**Project: White Deer Run Reservoir**  
**Project #: PW2017.010**  
**Bid Number: #23002**  
**Addendum #3**  
**Date: April 5, 2023**

### **BID DUE DATE EXTENSION**

### **QUESTIONS RECEIVED**

EXISTING SITE & DEMOLITION PLAN

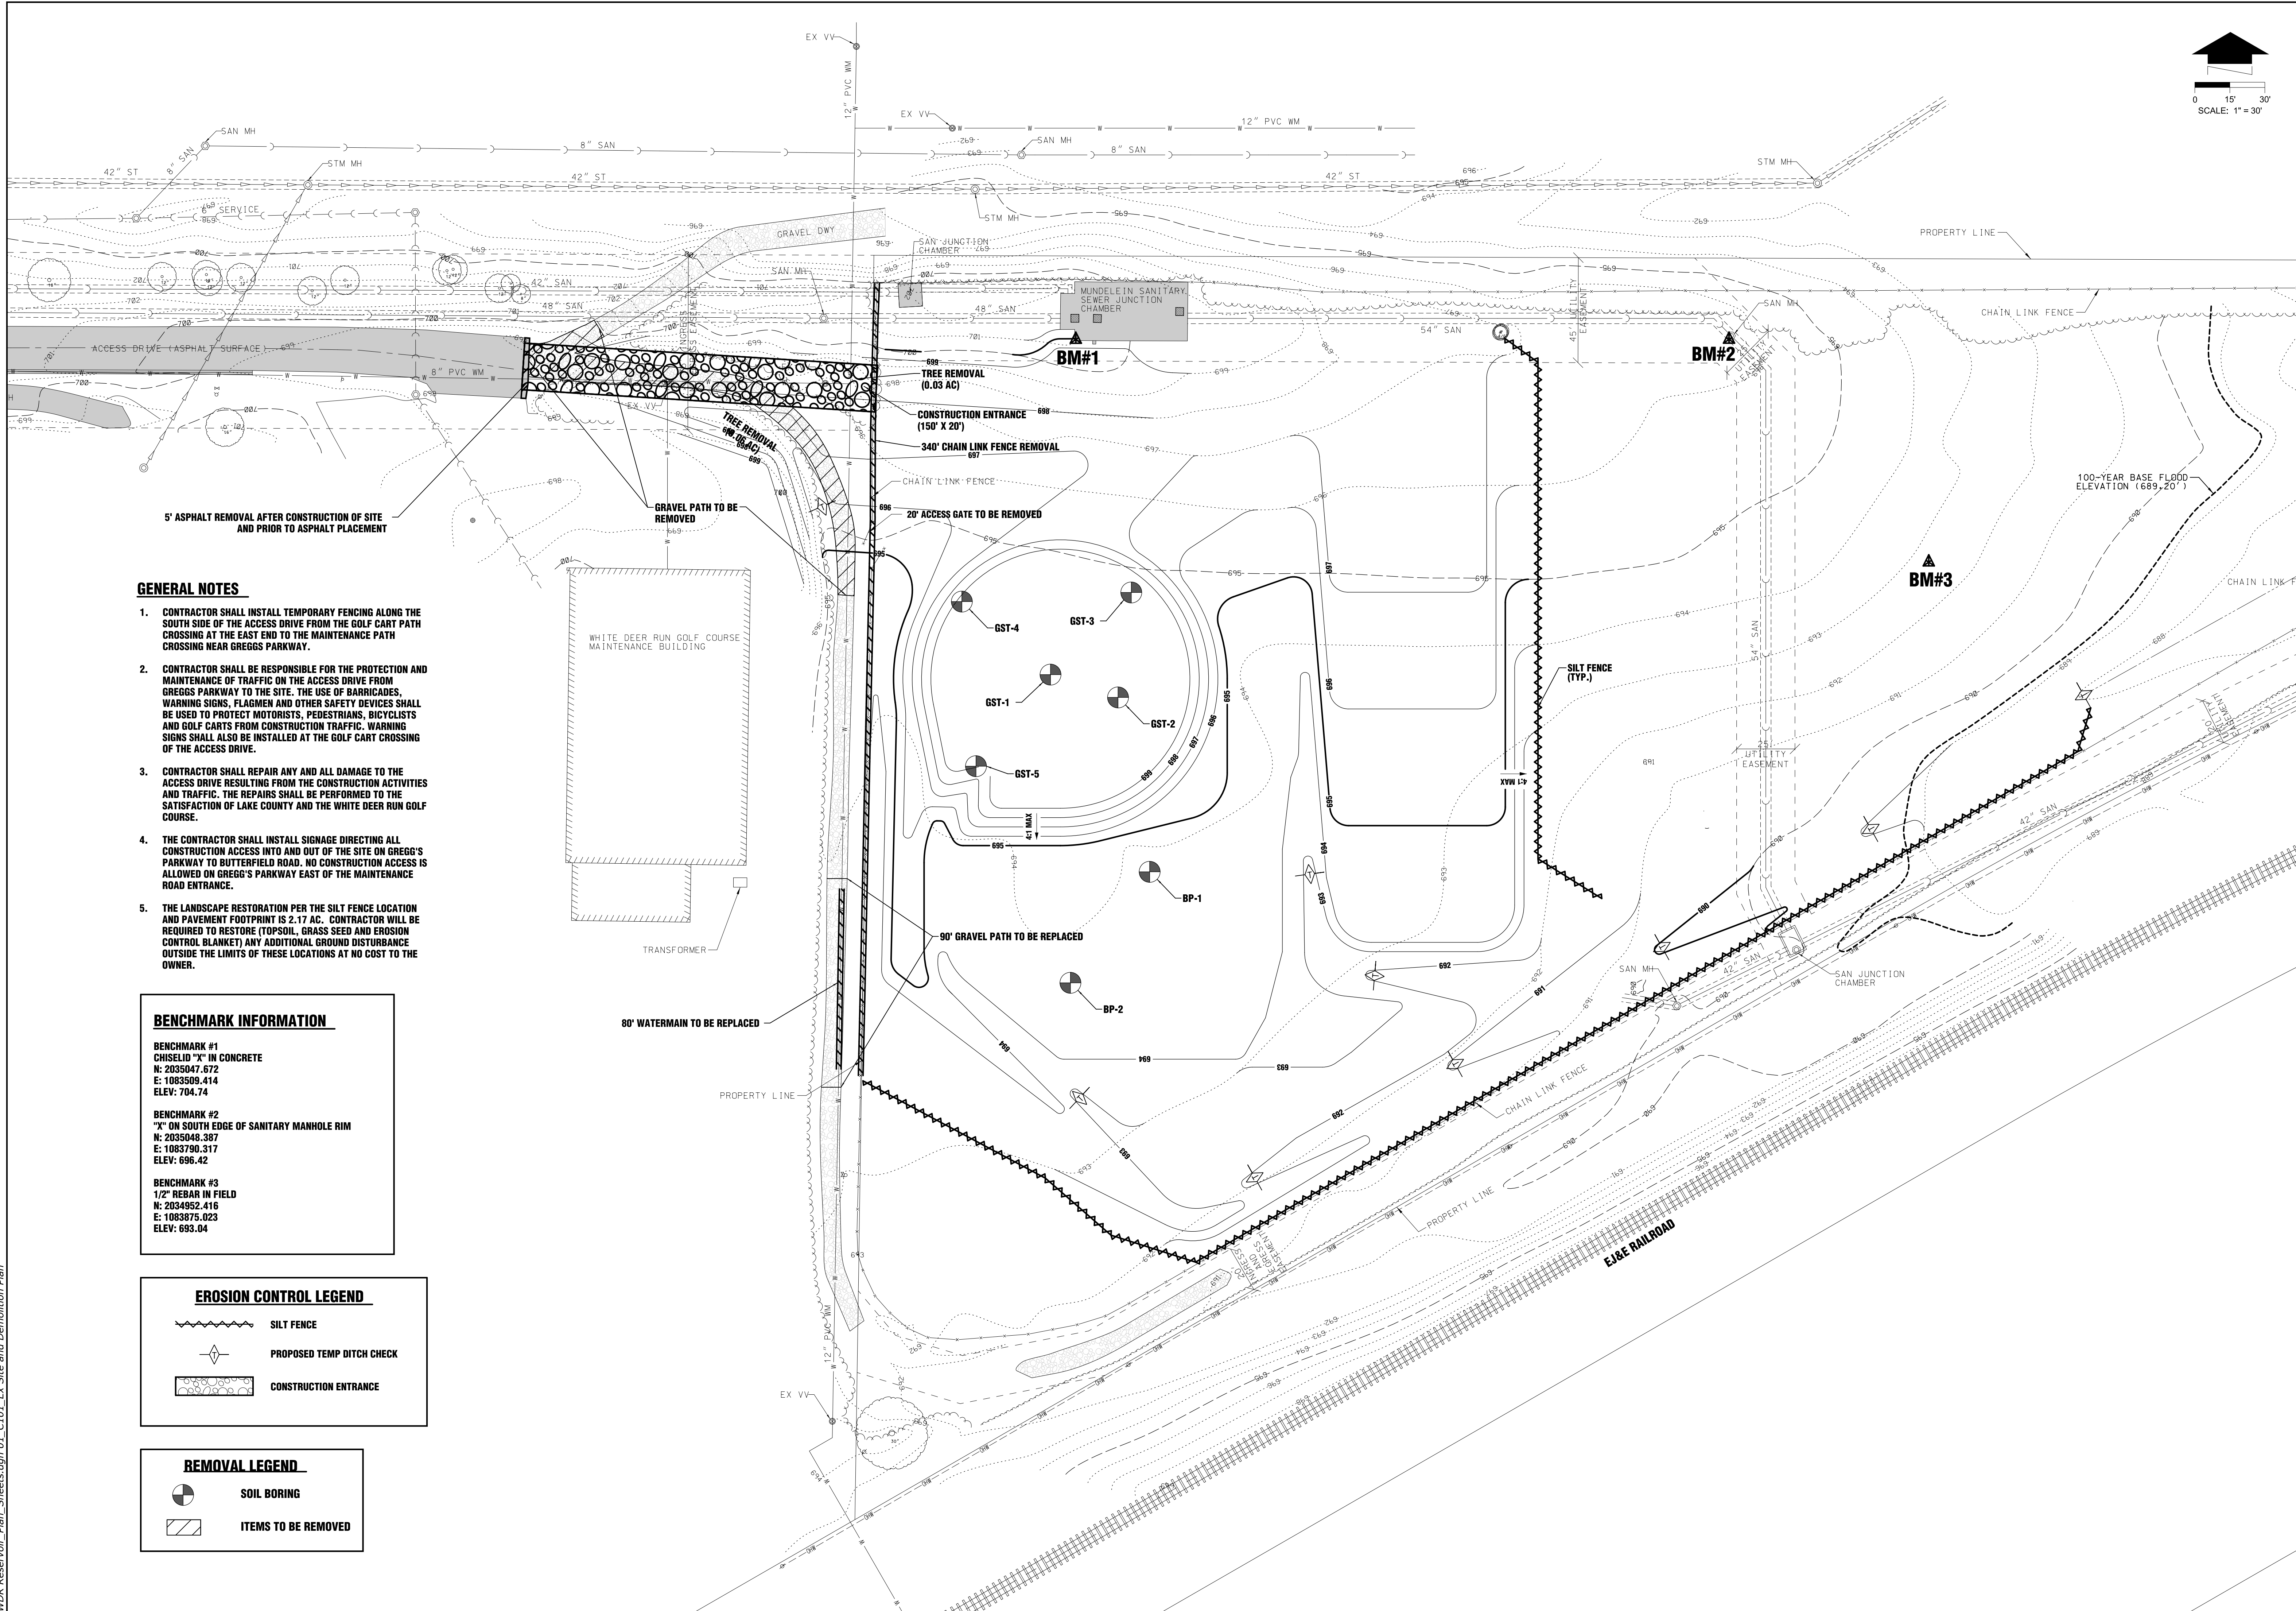
Question 22: Regarding Spec Section 02485-4 3.04 A in Lawn and Grasses, "Immediately after rolling seeded areas, place erosion control blanket over all areas that have been seeded. Unless otherwise indicated, also place erosion control blanket at sides and bottom of ditches, swales, and all areas within 10 feet of catch basins in seeded areas." Please clarify exact areas where erosion control blankets are needed, as the plans do not designate exact seeding or erosion control blanket areas?

Answer 22: Paragraph 02485 1.04.A. states, "All lawn areas disturbed by Contractor's construction activities shall be resorted to a grass cover by seeding." In addition, Sheet C102 clearly indicates proposed ditches and swales. Contractor needs to determine how much area they will disturb during the course of construction. The disturbed areas should be within the silt fence area delineated on Sheet C101 and is estimated to be 2.17 acres. See Sheet C101 Addendum No. 3 as attached.

1. See revisions to Sheet E1.0 Addendum No. 3 as attached to this Addendum.
2. See revisions to Sheet C101 Addendum No. 3 as attached to this Addendum. Added location of construction entrance and Note 4.
3. Sheet C103: Revise the following for the 6-inch and 8-inch sanitary sewer; the 6-inch and 8-inch sanitary sewer shall be SDR21.

2 PARTIAL ELECTRICAL SITE PLAN  
E1.0 NOT TO SCALE

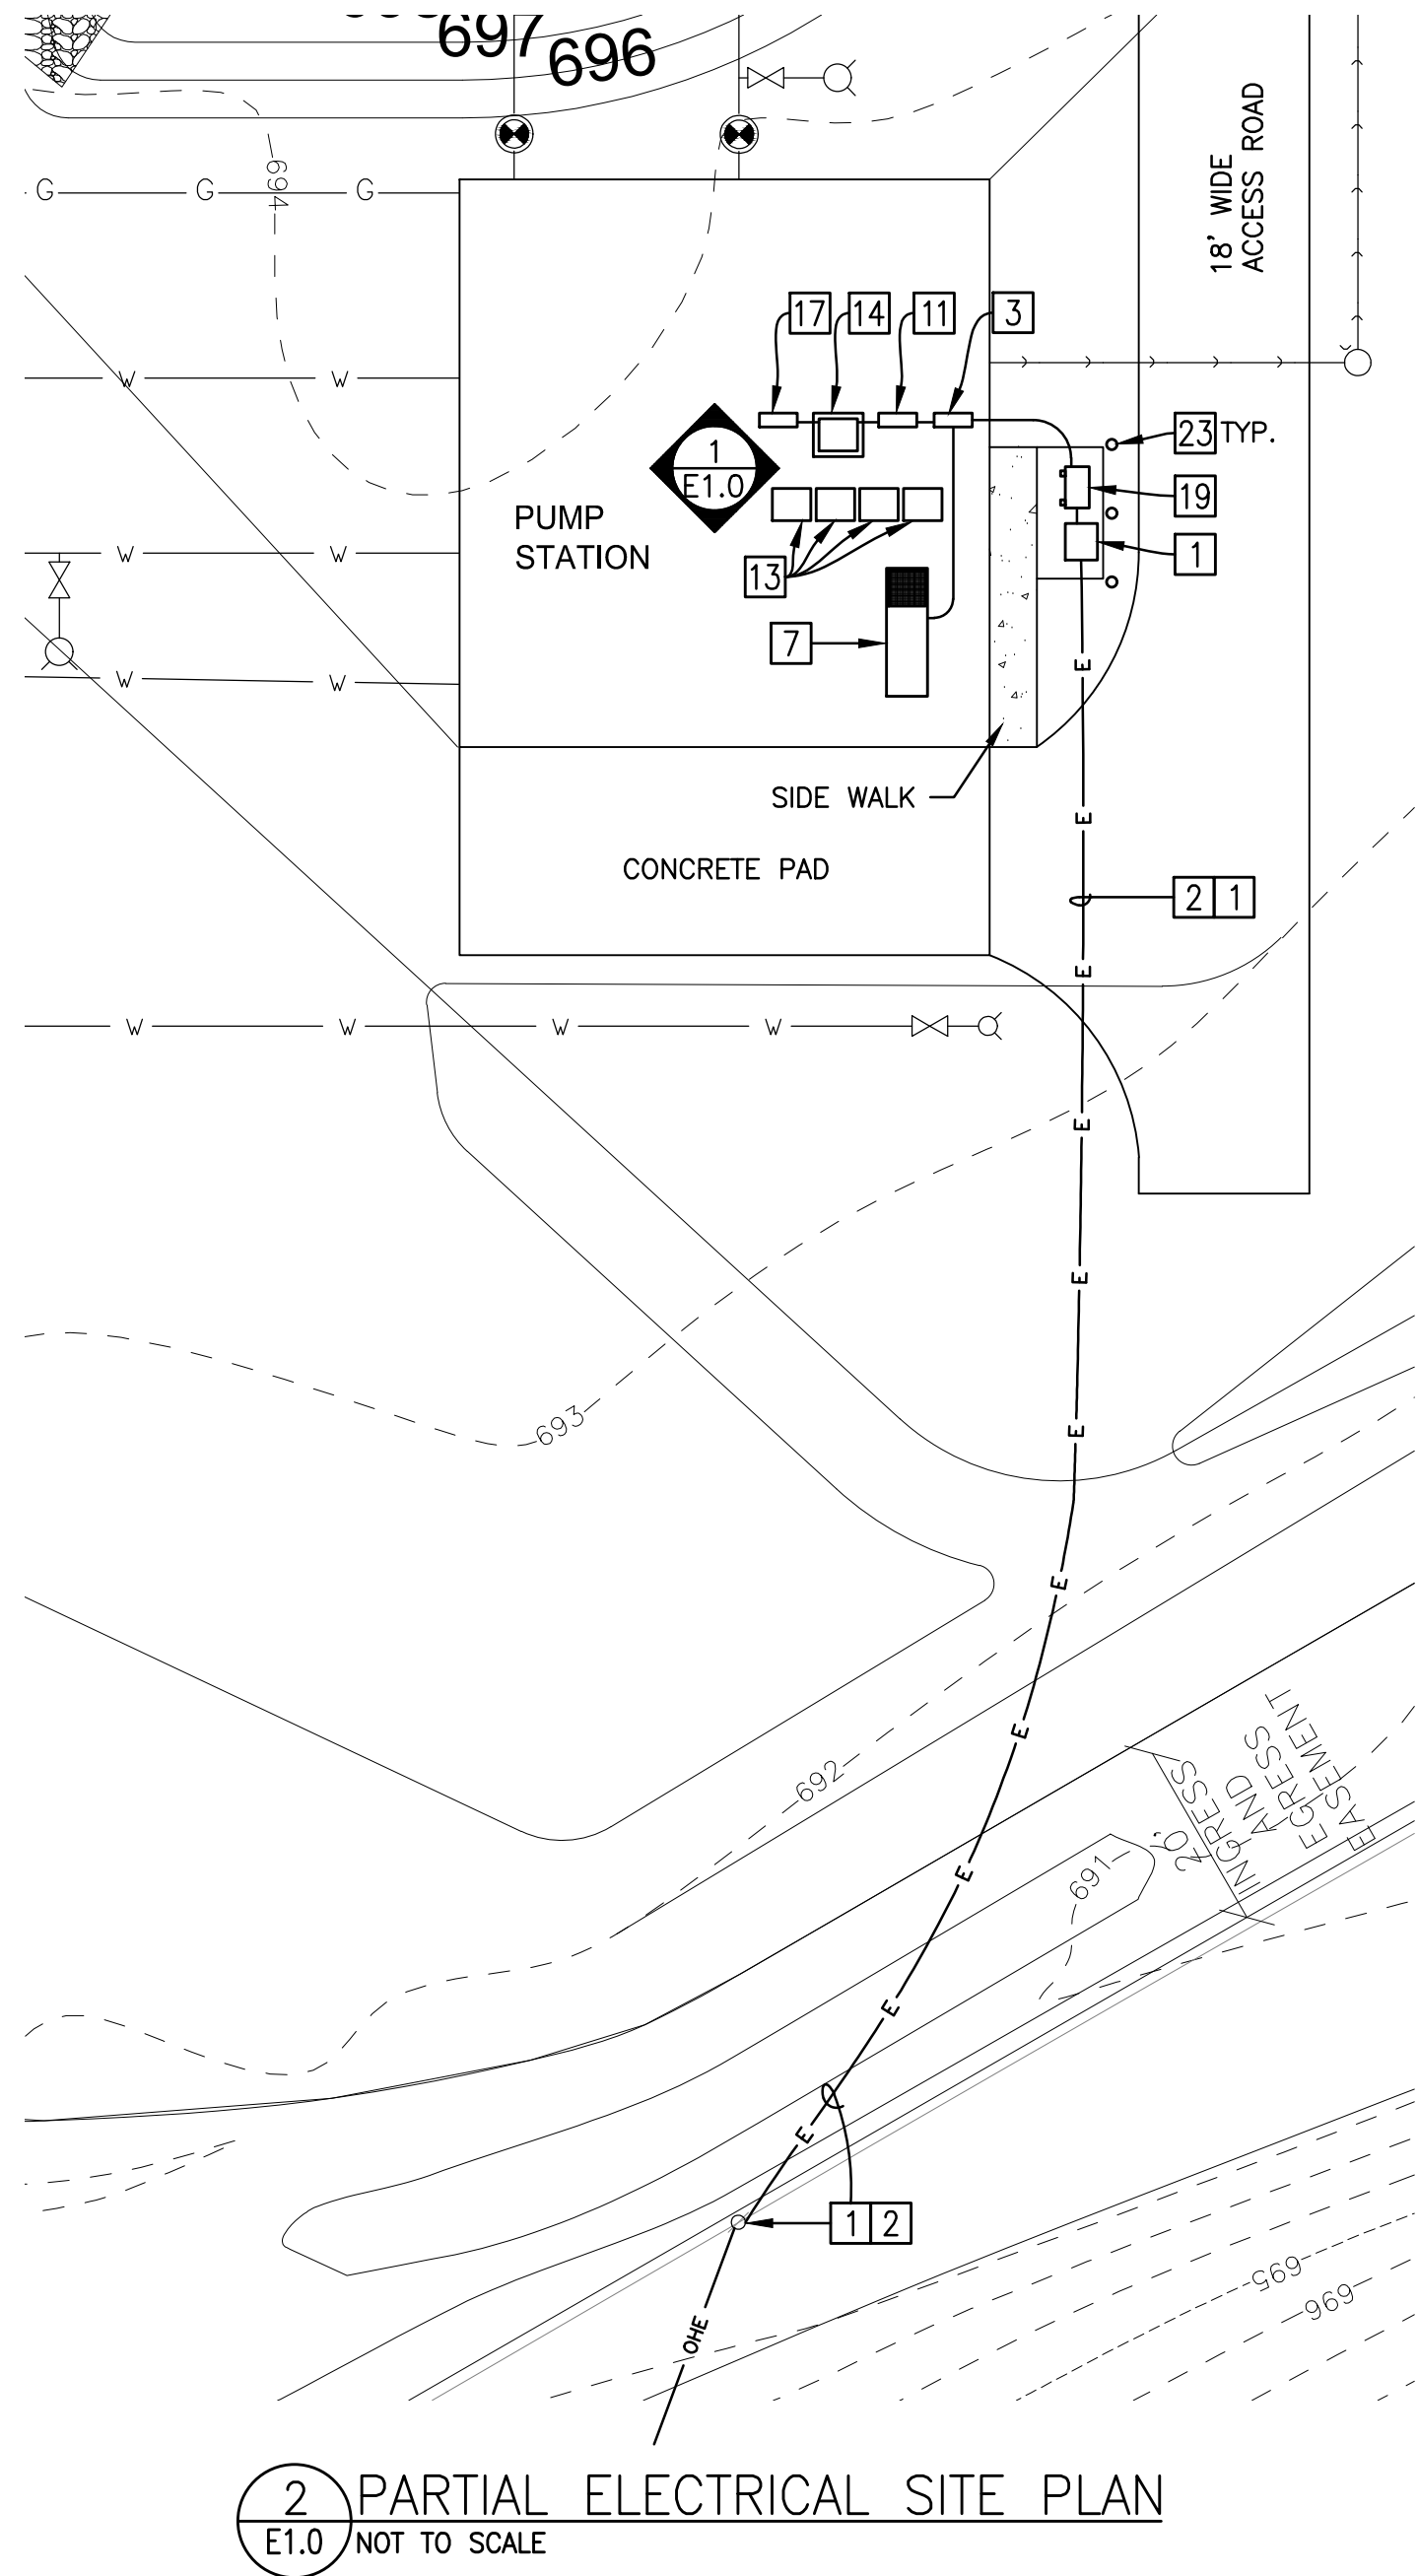
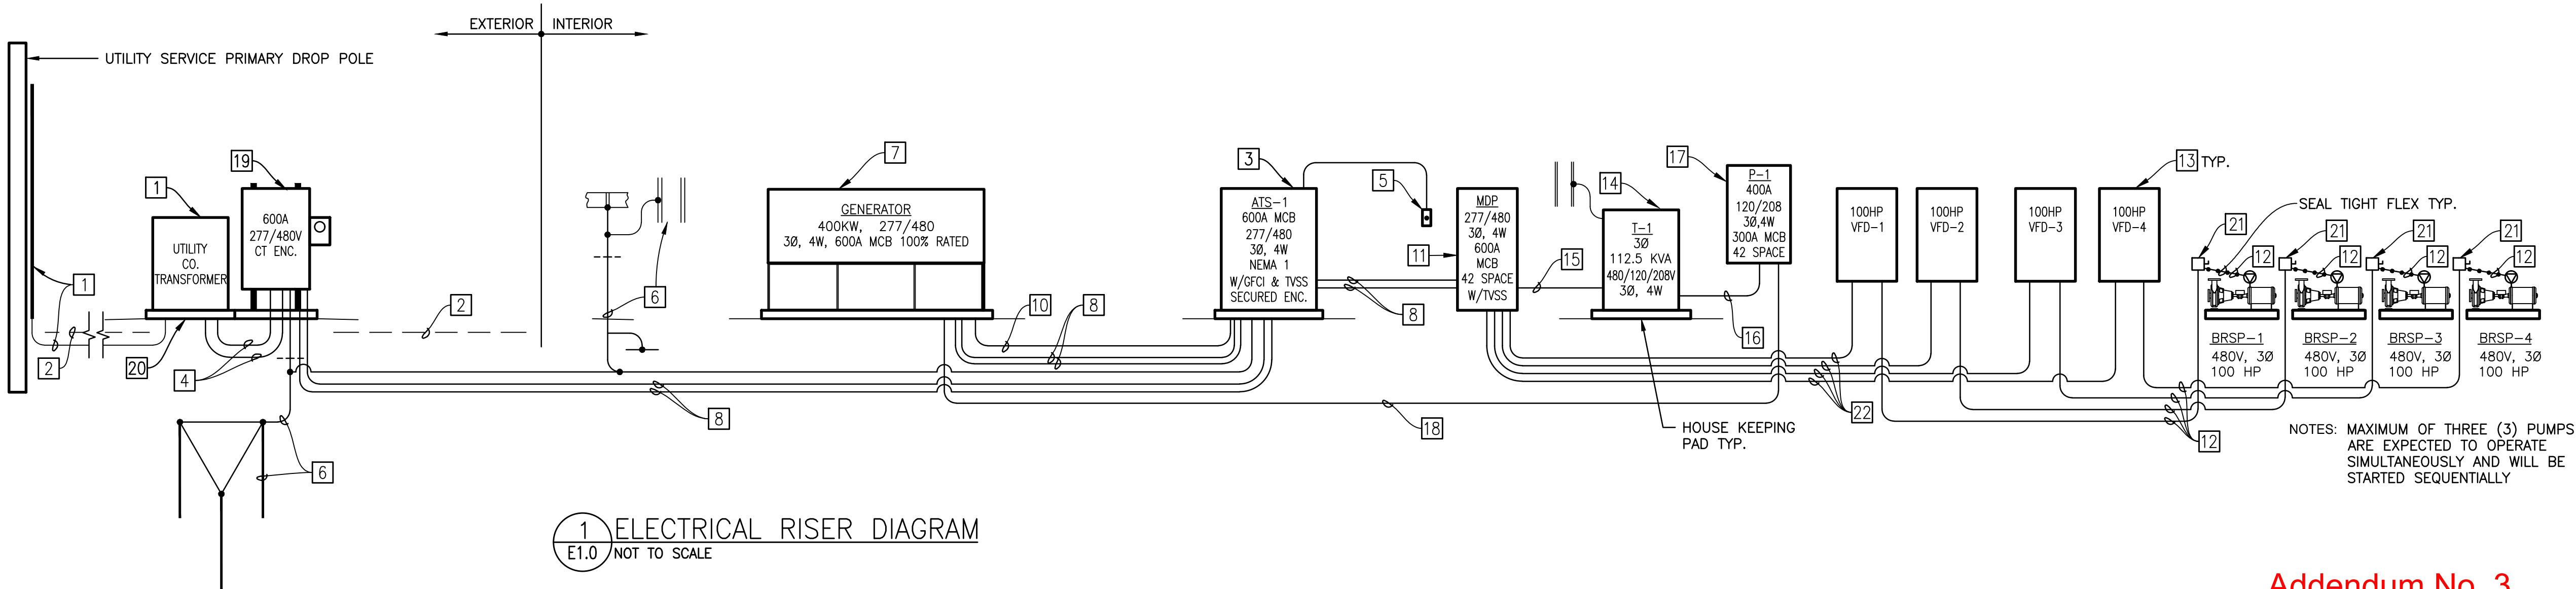
Question 37: There is no panel schedule for MDP.

Question 38: Sheet E101 from HMG shows an MCC in the electrical room. Please confirm there is no MCC on this project.

Question 39: The electrical room #104 layout shown on HMG plan sheet E101 & Cartland & Kraus plan sheet E1.0 do not match. It appears Cartland & Kraus plan sheet E1.0 is correct based off of the sheet Asaturian Eaton site plan sheet E1.0.

Question 40: Asaturian Eaton Plan Sheet E1.0:

- A. Is there a panel schedule for MDP showing breaker ratings and sizes?
- B. There is not a conduit tag for the Com Ed primary conduit from the pole to the transformer. Please confirm if the EC is to furnish and install an empty conduit form the Com Ed furnished and installed primary cable, and if so please confirm the size.
- C. The cable from the MDP to the VFD is called out as TAG #12 which is "Drive Flex Cable". Please confirm if "Drive Flex Cable" is needed from the MDP to the VFD, or only from the VFD load side to the pump.
- D. The tank access hatch sensors are not shown on this plan, but shown on Hezner sheet T100. Please confirm conduit and cable to these sensors.

Question 47: Does the electrician install the underground conduit from the onsite ComEd Transformer to the service drop / pole at the road and what size and how many conduits?

Answer 37: See attached revised sheet E1.0, Addendum No. 3.

Answer 38: See attached revised sheet E1.0, Addendum No. 3.

Answer 39: See attached revised sheet E1.0, Addendum No. 3.

Answer 40: See attached revised sheet E1.0, Addendum No. 3 for Items A through C. Item D, see sheet E101 Conduit Schedule. Item E, see sheet E101 Conduit Schedule.

Answer 47: See attached revised sheet E1.0, Addendum No. 3.
